South Texas Project
Units 3 and 4
Docket Nos. 52-012 and 52-013
Response to Request for Additional Information

Attachment 1 is the Nuclear Innovation North America LLC (NINA) response to the NRC staff question 03.07.01-29 included in Request for Additional Information (RAI) letter number 378 related to Combined License Application (COLA) Part 2, Tier 2, Section 3.7.1.

RAI 03.07.01-29**QUESTION:**

RAI 03.08.04-19, Supplement 2**QUESTION:****Follow-up to Question 03.08.04-5 (RAI 2965)**

Figure 3H-6-138. RSW Piping Tunnel, Horizontal Response Spectra

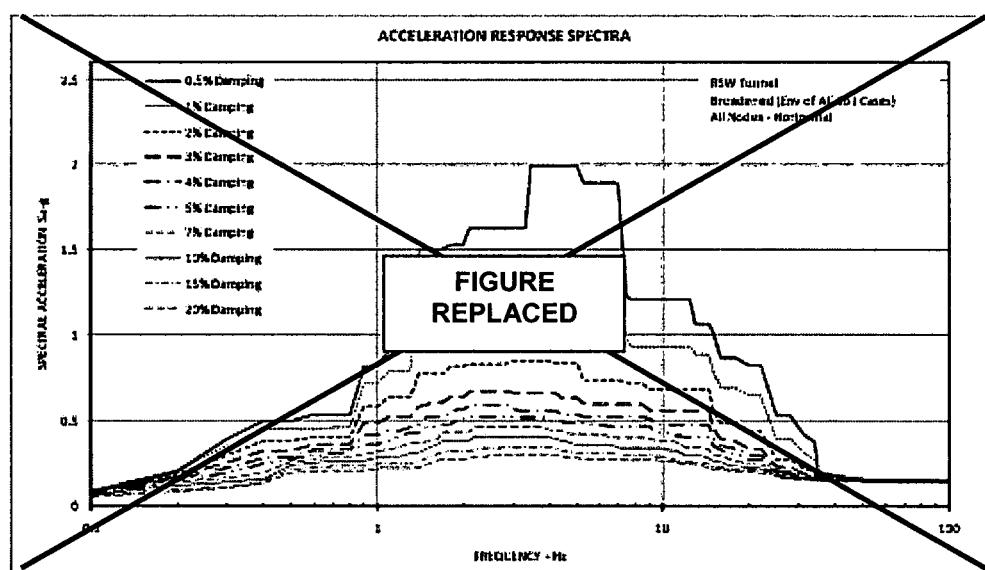
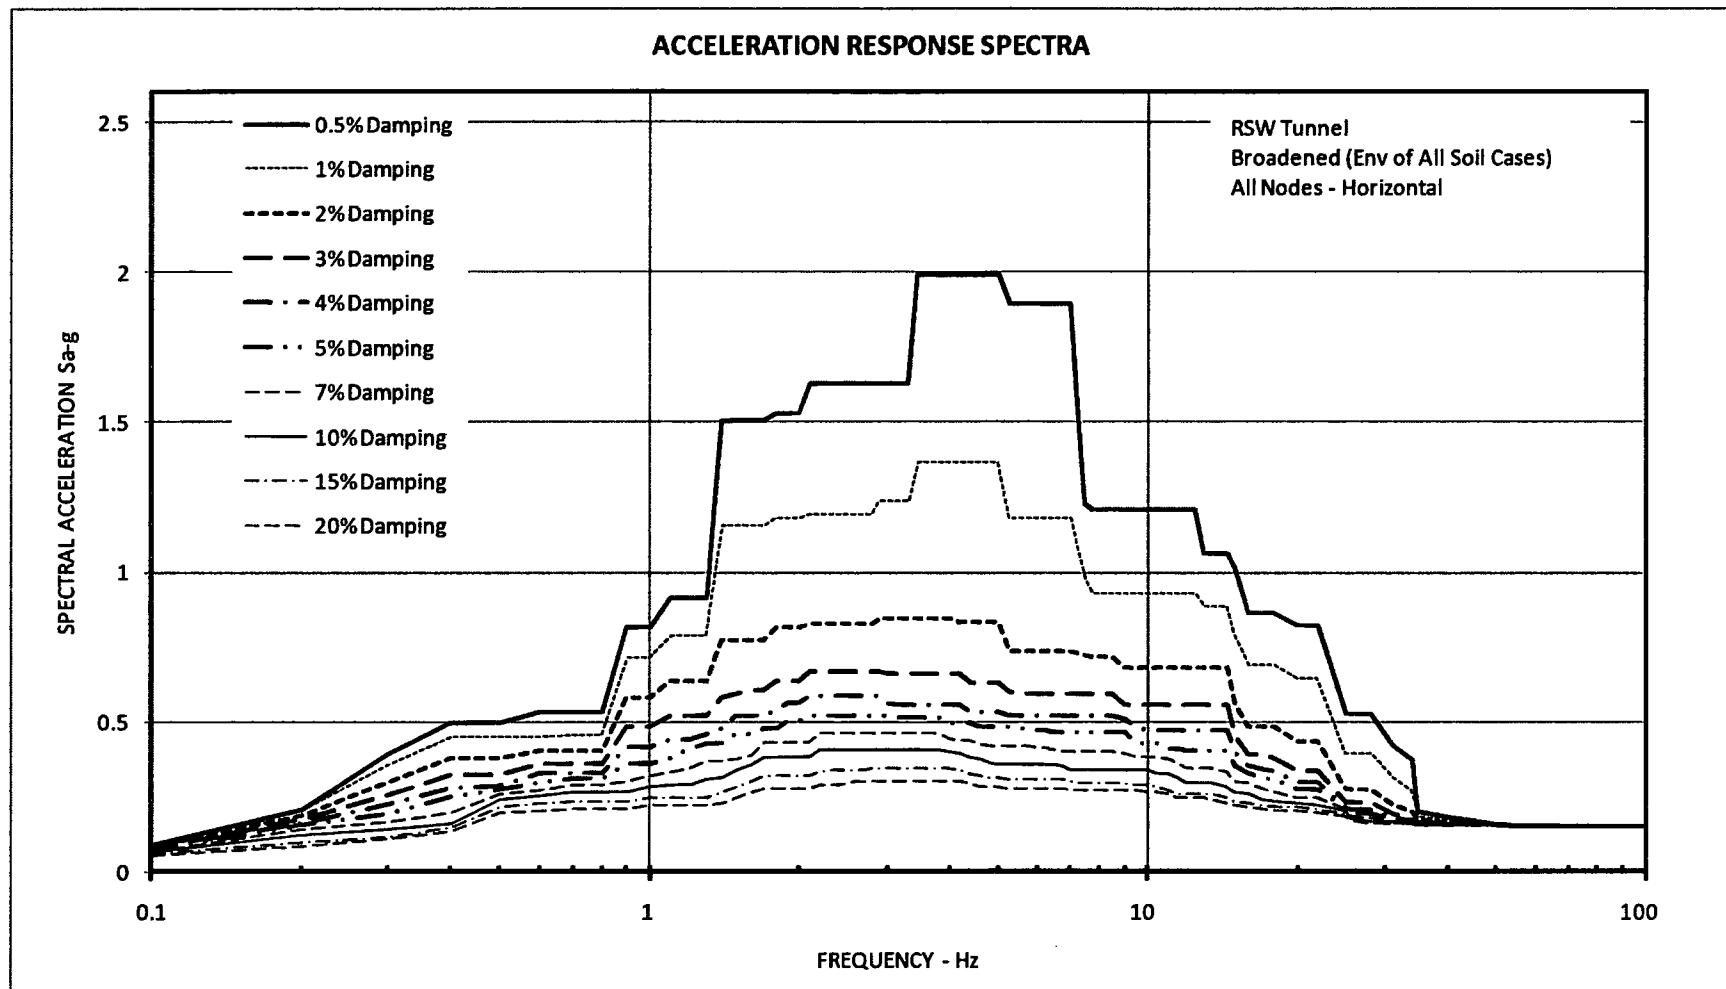
- c. Provide legible COLA Figures 3H.6-138 and 3H.6-139 (Audit Action Item 3.8-30, Punch List Item 78)

Legible copies of Figures 3H.6-138 and 3H.6-139 have been provided as COLA mark-up in Enclosure 1.
